# Product Change Notification

## E8T PCB Update

PCN-6514

Figure 1, E8T PCB comparison showing existing design (left) vs. new board design (right).

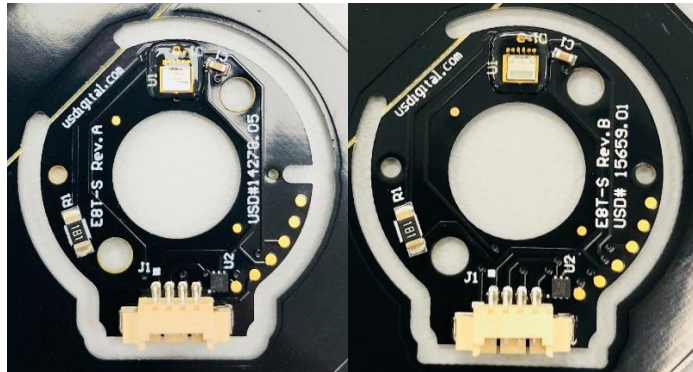
This notice is to inform our customers of a PCB design change that is being implemented for the entire E8T product line.

As part of our continuous improvement objective, the new PCB will improve overall product performance and enhance robustness of this product line. The new PCB has two mounting holes that mate with the base plate instead of one hole and one slot. This change has no impact on form, fit or function for the E8T.
